Work Order ID 56426

Item Name: Basket Hoop

DRAWING NO. D3166	TITLE BASKET HOOP	REV A1	DART AEROSPACE LTD ENGINEERING ORDER		D.E.O. NO. D3166-A-2	SHEET NO. 1 OF 1	SCALE NTS
DRAWN AJS	CHECKED 1	MFG. APPR. M	APPROVED MD		DE APPR. H		
DATE 08.12.11	DATE 08.12.15	DATE 08/12/15	DATE 08/12/16		DATE 08.12.16

D3166-1 BASKET HOOP

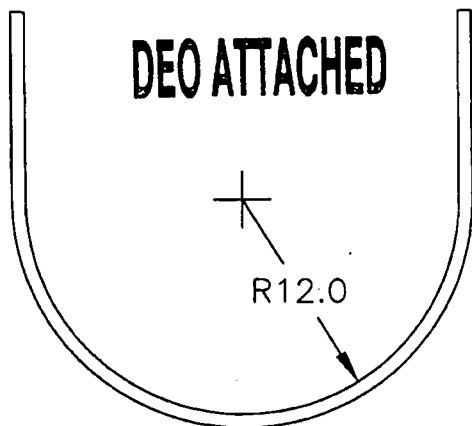
1) MODIFY MATERIAL NOTE FOR D3166-1 AS SHOWN:

WAS:

1) MATERIAL: AISI 304/316 SS SQUARE TUBING,
0.75" x 0.75" x 0.063 WALL, 60.00" LONG
(REF DART SPEC. M304TS0.750W.063)

IS:

1) MATERIAL: AISI 304/316 SS, 3/4 X 3/4 X 0.065 WALL SQUARE TUBING,
60.00" LONG
REF. DART SPEC M304TS0.750W.065

D3166-3 BASKET HOOP

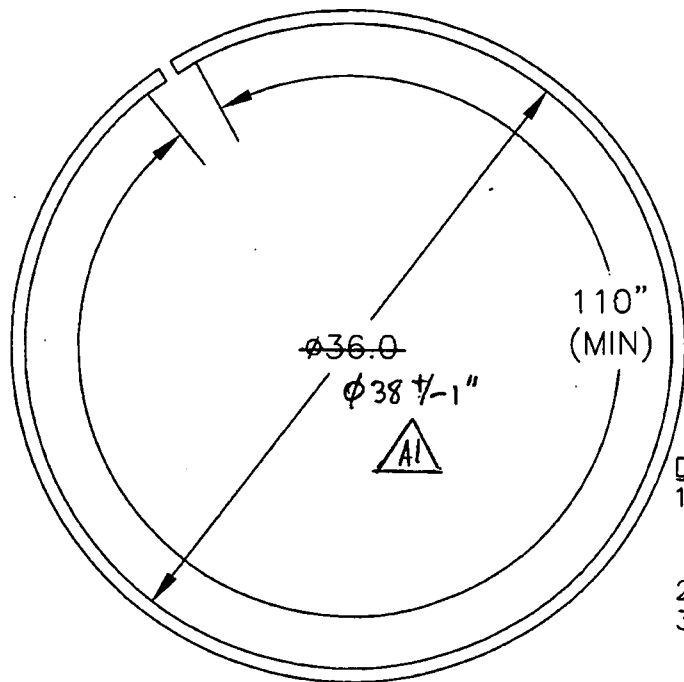
2) MODIFY MATERIAL NOTE FOR D3166-3 AS SHOWN:

WAS:

1) MATERIAL: AISI 304/316 SS SQUARE TUBING,
0.75" x 0.75" x 0.063 WALL, 120.00" LONG
(REF DART SPEC. M304TS0.750W.063)

IS:

1) MATERIAL: AISI 304/316 SS, 3/4 X 3/4 X 0.065 WALL SQUARE TUBING,
120.00" LONG
REF. DART SPEC M304TS0.750W.065
